RE: Scoping Comments of Carol A. Overland
Hiawatha Project Environmental Report

Thank you for the opportunity to submit ER Scoping Comments on the Hiawatha transmission project.

The Preferred Plan is the Hiawatha345 Option, which adds the following facilities:

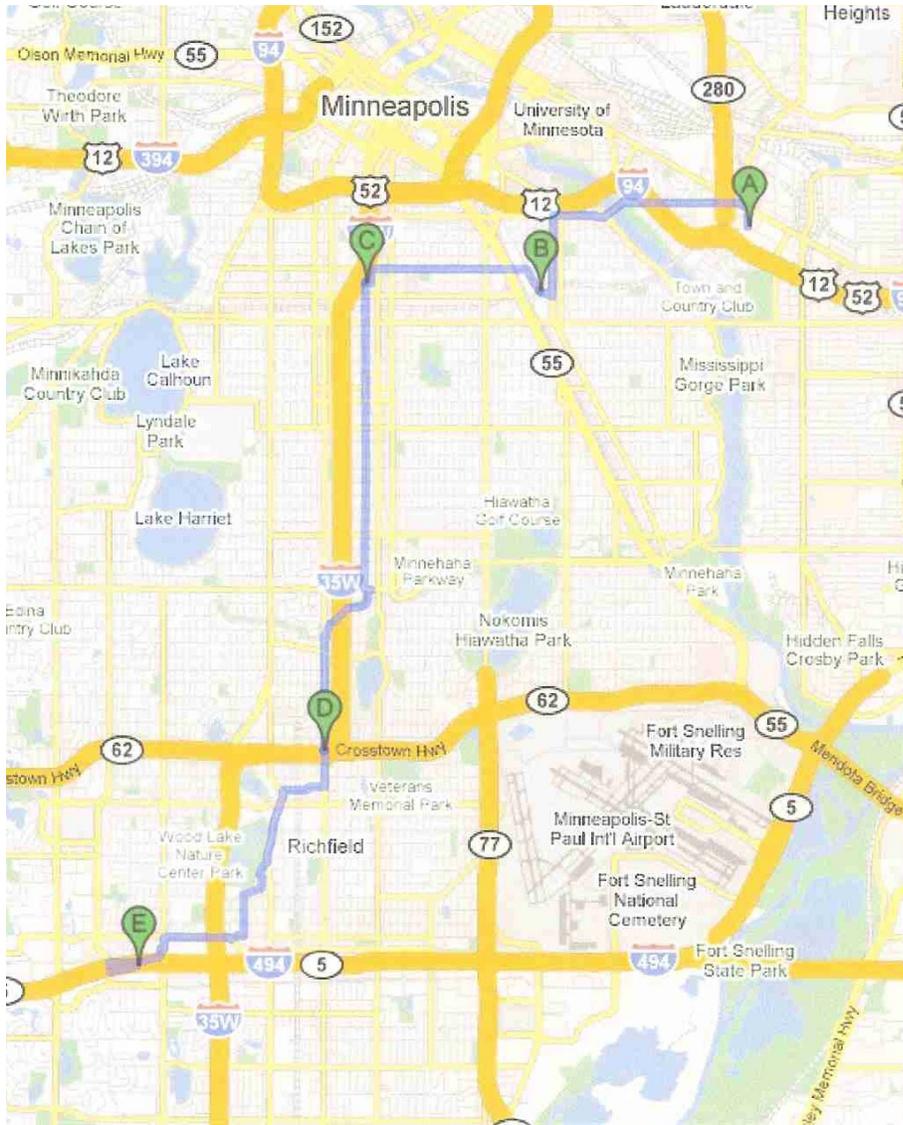
The claimed purpose is quite different than what the specifics of the application reveal. There has been no need determination regarding this project to provide thorough review of Xcel’s need claim. And although Xcel’s need claim is a distribution deficiency, the “solution” is a several times larger than “needed” transmission line.

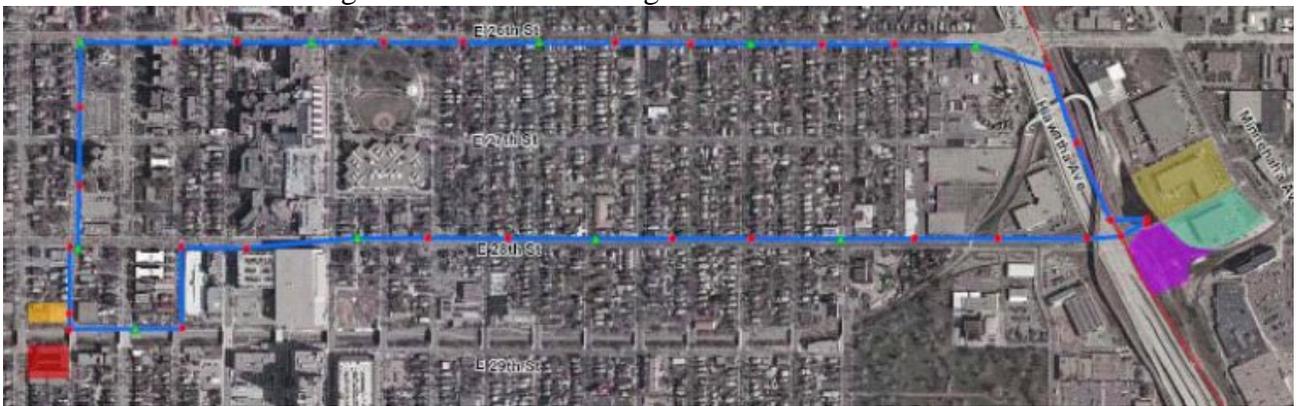
A quick look at the route demonstrates that overhead construction is not feasible, easement acquisition is not feasible, and protection of the public health and safety is not feasible:

The alternative route configured as two 115kV single circuits:

Any route down 31st Street is as absurd.

Attachment 4 – Birds Eye View of Blowout Near Mn/DOT ROW
Page 1 of 1

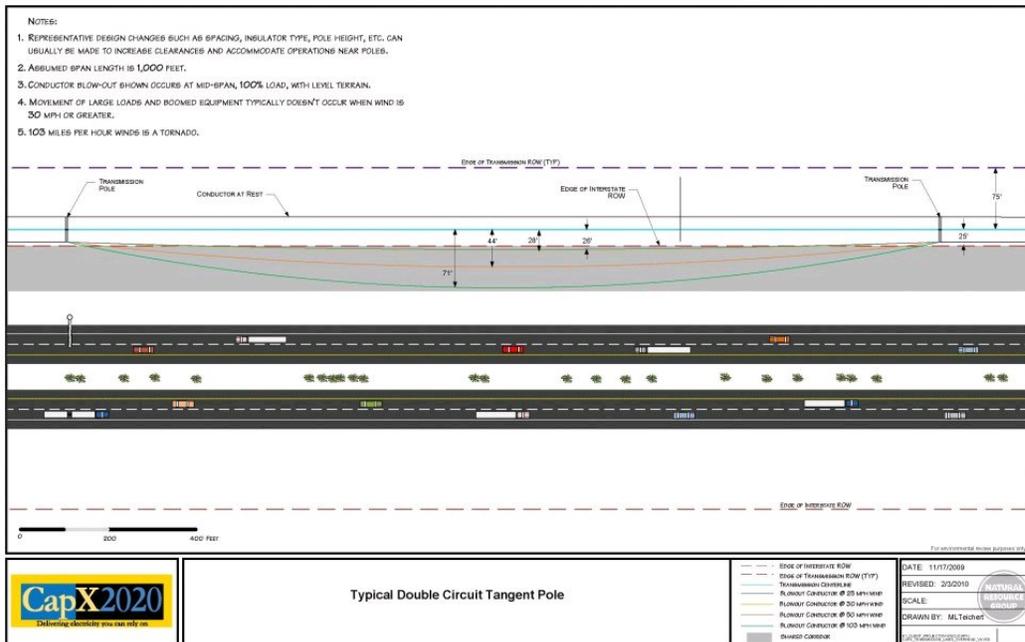
In other transmission dockets, conductor blowout of above-ground transmission conductors is a factor for easement acquisition and in DOT corridor sharing.

This project, if constructed overhead, would cut through a tightly compacted business and residential community. A birds-eye blowout diagram, such as the one provided in Poorkers CapX Post-Hearing packet, provides an important concept that should be considered. (However, the birds-eye blowout diagram was inaccurately drawn and measurements were from the centerline, not the connecting point of the conductor, and this should be corrected.) Blowout means that in high winds, the conductor stretched between two poles, sagging, literally blows out, from its sagging downward position, and can even extend beyond the right of way. In a city where buildings are close, this should be a primary public health and safety concern.
